STAFF RECOMMENDATION
2020 10th Avenue South
March 20, 2019

Application: Demolition-Partial; New Construction—Addition;
District: Waverly-Belmont Neighborhood Conservation Zoning Overlay
Council District: 17
Map and Parcel Number: 10509041200
Applicant: Tarl LaRocco
Project Lead: Melissa Baldock, melissa.baldock@nashville.gov

Description of Project: Application is for a two-story addition behind the historic one-story house. The project involves enclosing a side porch and altering window openings. **Recommendation Summary:** Staff recommends approval of the window opening alterations and the demolition of the rear addition, detached garage, and detached carport, finding that their demolition meets the guidelines' Section V.B.II. for appropriate demolition. Staff recommends disapproval of the partial demolition of the front door frame and other detailing on the historic house, finding that it does not meet Section V.B.II. for appropriate demolition but rather meets Section V.B.I. for inappropriate demolition. Staff also recommends disapproval of the addition, finding that its height, scale, design, removability, and roof form do not meet Sections III. and IV. of the design guidelin

Figure 3. The plat showing the creation of two lots out of the previous larger lot at 2020 10th Avenue South.

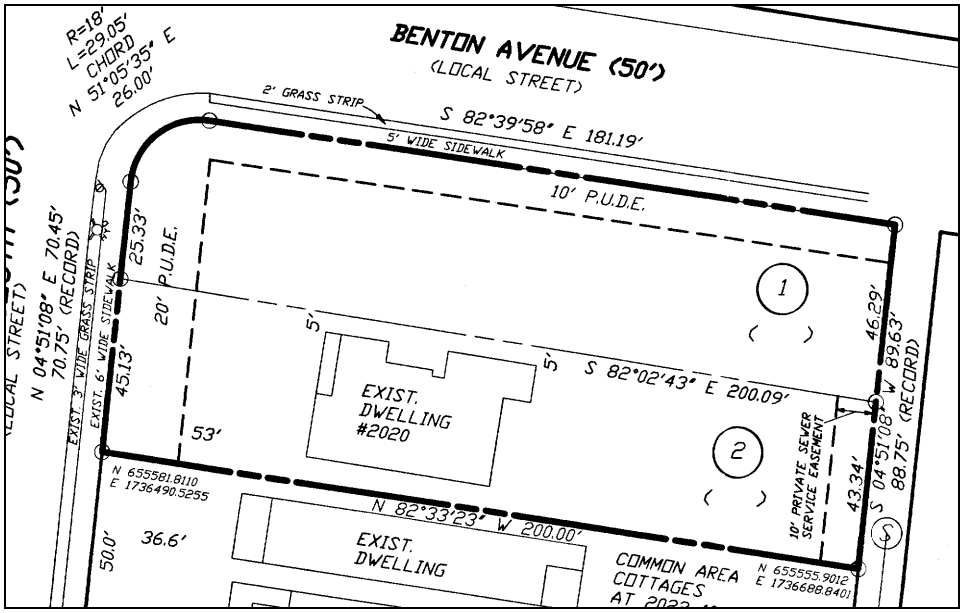
Until 2018, the house sat on a larger, wider lot. In 2018, Metro subdivided the lot into two parcels (Figure 3). As a result, the lot at 2020 10th Avenue South became narrower than typical lots in the area at approximately forty-five feet (45') wide at the front. MHZC approved new infill construction, with conditions, for the newly created parcel at 2018 10th Avenue South in July 2018. MHZC staff never received revised drawings

Figures 8 & 9 show the proposed window alterations to the side of the historic house. Staff finds these alterations to be appropriate.

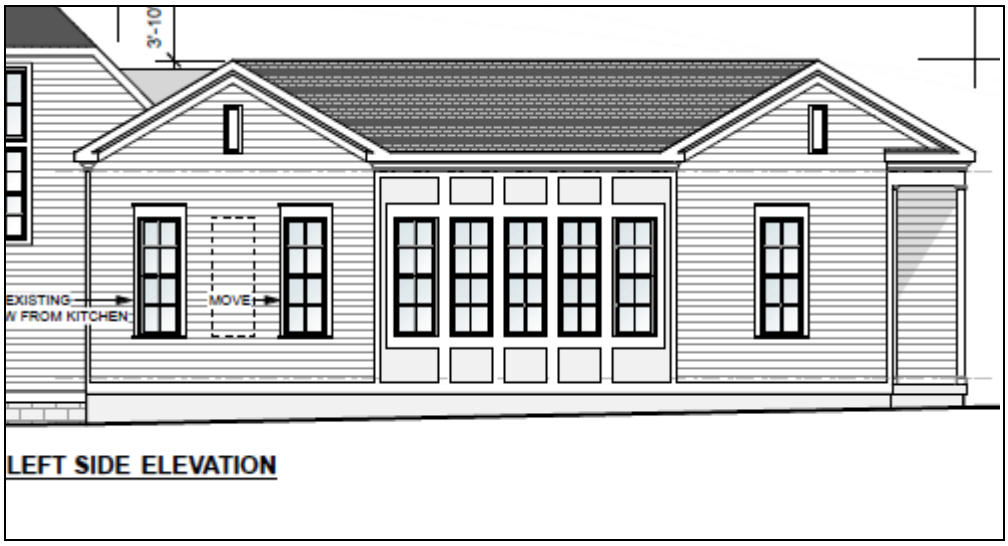
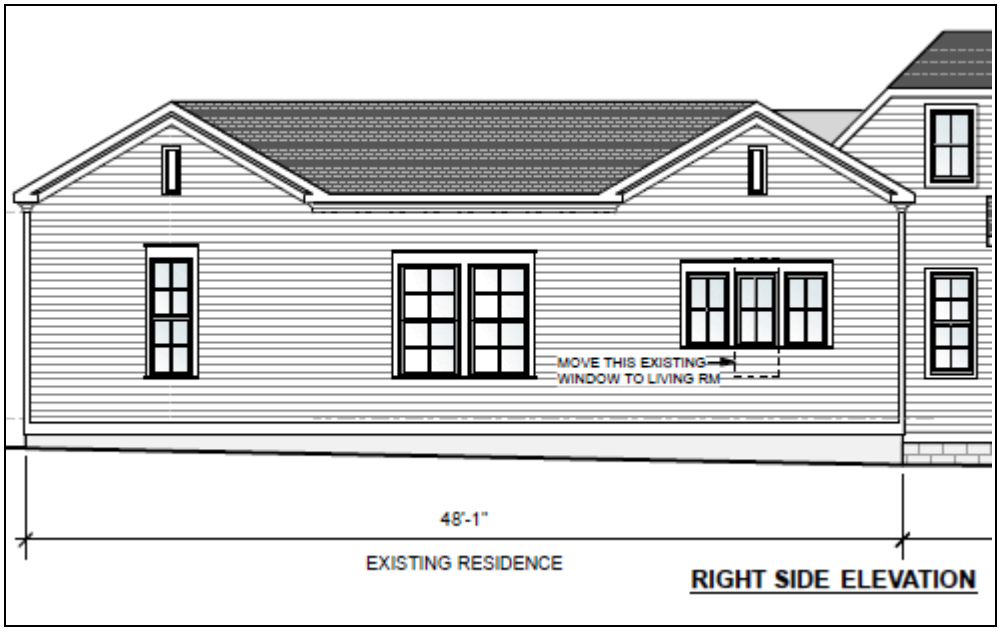
The applicant is proposing to alter window and door openings on the right and left facades towards the back. Alteration to window openings on the historic house is considered to be partial demolition. On the left elevation, the applicant is intending to move the existing window opening slightly to the right and to move the existing window opening from the back of the right elevation to this façade (Figure 8). The window opening on the right will be replaced with three shorter window openings (Figure 9). Because these window alterations are happening towards the back of the historic house

and because the applicant intends to use the same casings and windows, staff finds these alterations to be appropriate.

Figure 10. Staff finds that the removal of the appendage at the rear of the house to be appropriate.

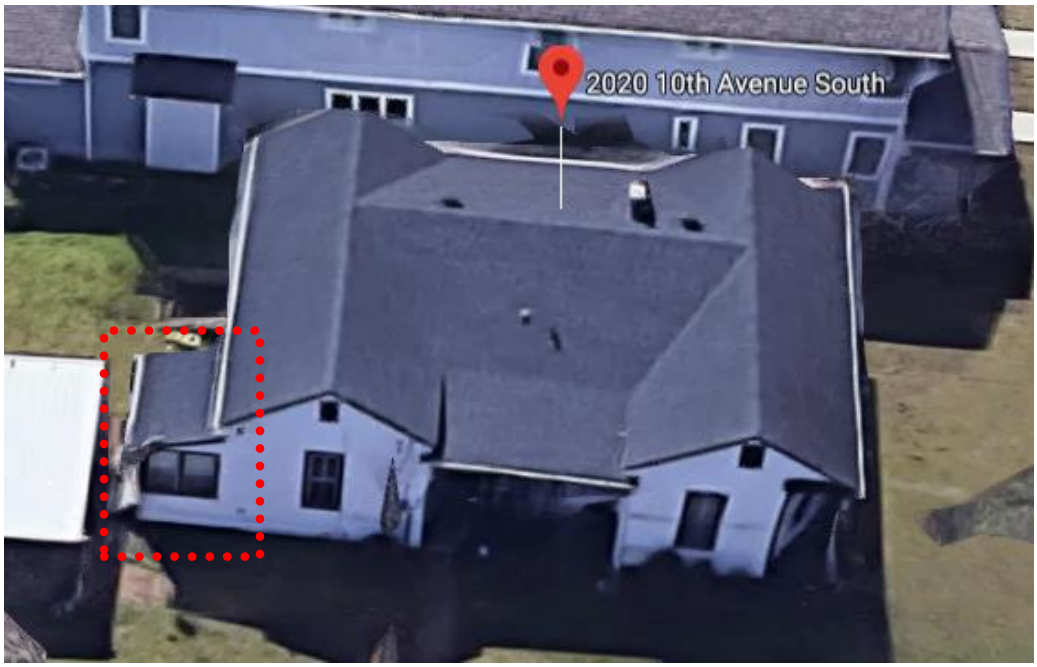
The applicant is proposing further to remove a small, rear porch portion of the house (Figure 10). The rear porch of the house is not seen in any of the older maps for the house and was therefore likely constructed after 1957. The structure has a separate roof form from the rest of the house, and staff finds that its date of construction, location at the rear of the house, and roof form do not contribute to the historic character of the house. Finally, the applicant is proposing to remove a detached rear carport and a detached garage (Figure 11). Neither structure appears on the 1957 Sanborn map, and neither

contributes to the historic character of the house, the site, or the overall neighborhood. Staff therefore finds demolition of the rear porch, garage, and carport to be appropriate.

Figures 13 & 14. The floor plan and elevation showing the area of the enclosed porch.

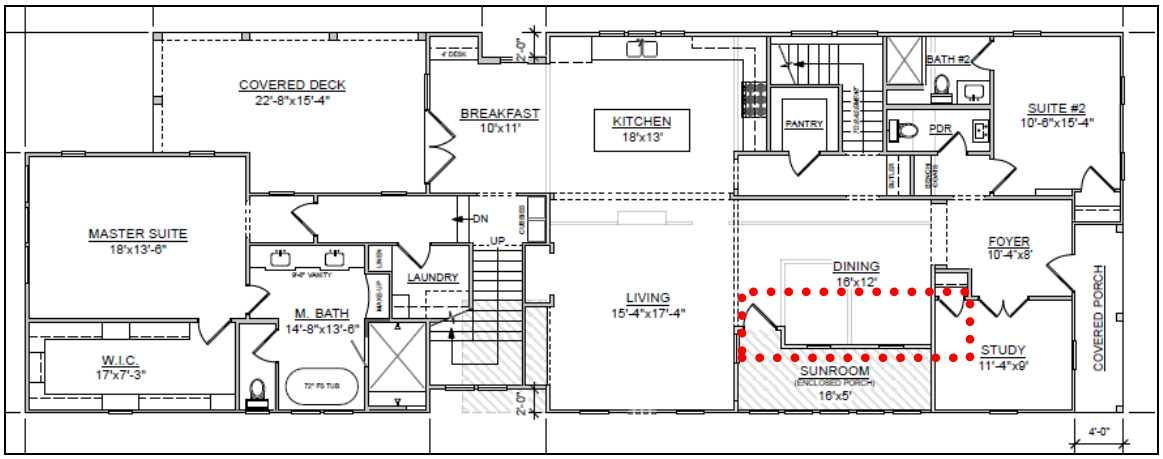
Design: Staff finds that the addition's height, scale, and taller roof form contrast greatly with the historic house at 2020 10th Avenue South. In addition, staff finds that the design of the proposed enclosure of the side porch is not appropriate (Figures 12, 13, and 14). Although the plans show that the exterior wall will remain, staff finds that the design of the enclosure lacks the transparency and openness required to indicate that this was once an open porch. The Sanborn maps from 1908, 1914, and 1957 all show that this area was always a side porch (Figures 15, 16, and 17). Staff finds the side porch configuration is a significant part of this historic house's form and should be preserved. Staff therefore recommends that the side porch element be designed to be more open in nature so – for instance all glass or screened – so that the exterior wall can still be read through the enclosed porch. The addition of posts to the enclosure would further help to make the element read more as an enclosed porch rather than a new wall.

SITE PLAN

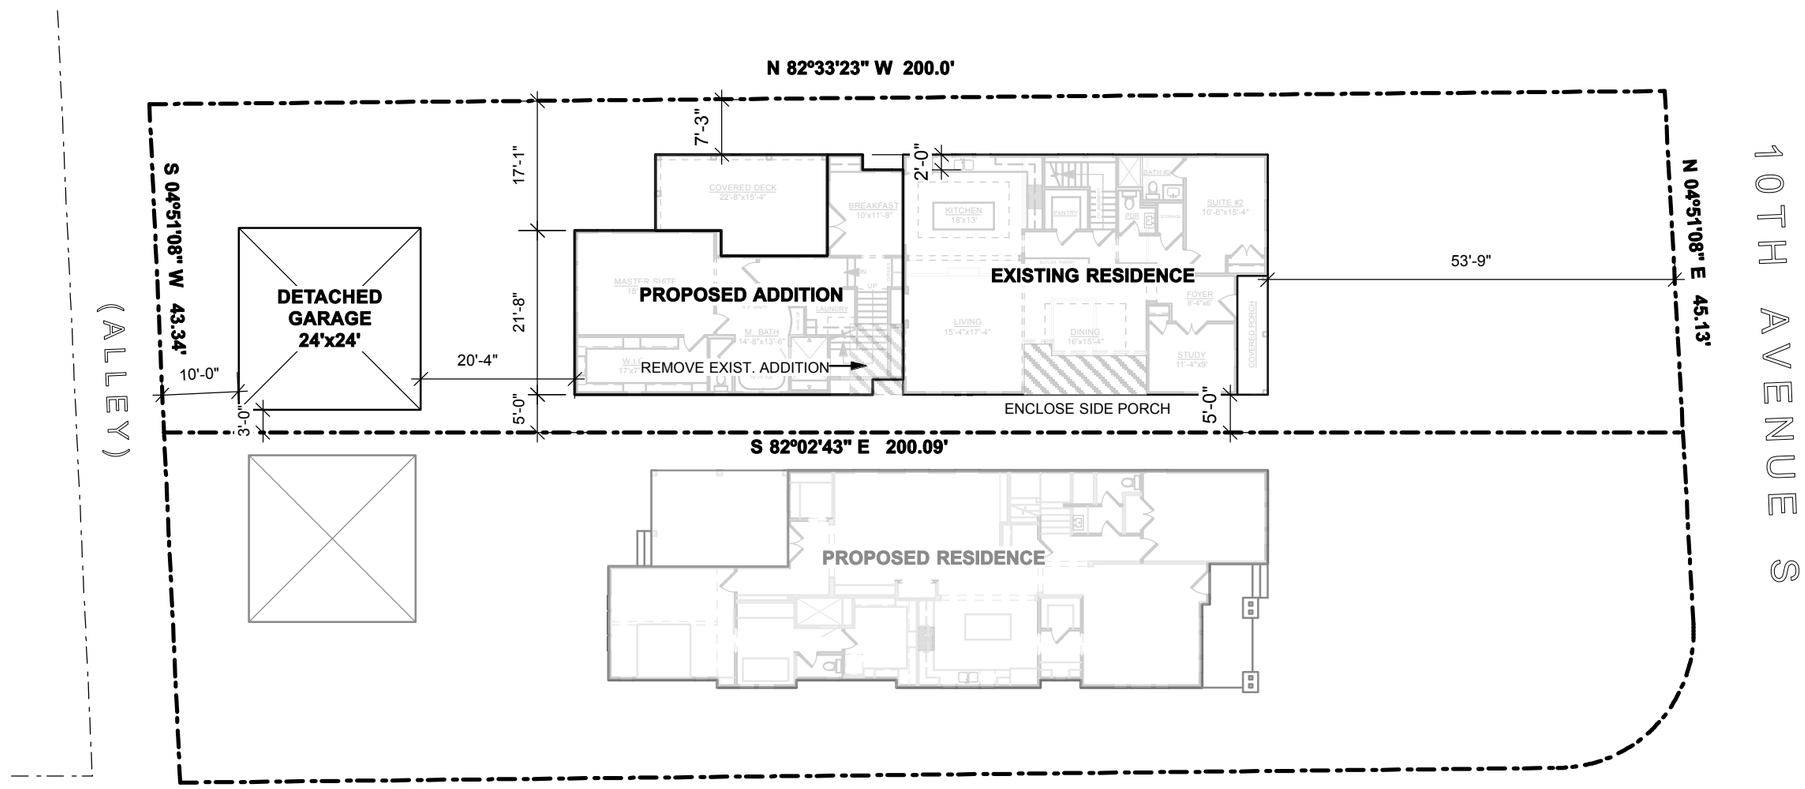
<u>Setback & Rhythm of Spacing:</u> The site plan shows that the addition meets all base zoning setbacks. It shows that the addition will be five feet (5') from the left side property line and seven feet, three inches (7'3") from the right side property line. It will be over fifty feet (50') from the rear property line. Staff notes, however, that the first floor plan shows different setbacks. It shows the addition as being four foot, six inches (4'6") from the left side property line and seven feet, seven inches (7'7") from the right side property line. Since the official survey for the lot shows the existing house as being five feet (5') from the side property line and both plans show the addition as lining up with the historic house, staff assumes that the site plan is correct and the first floor plan is erroneous. Although staff finds that the proposed setbacks as shown on the site plan are appropriate and meet Sections III.C. and IV. of the design guidelines, staff recommends that all future drawings show the accurate setbacks.

Outbuildings: Although the site plan shows a garage, no elevation drawings were submitted for the outbuilding. The outbuilding is therefore not part of this application.
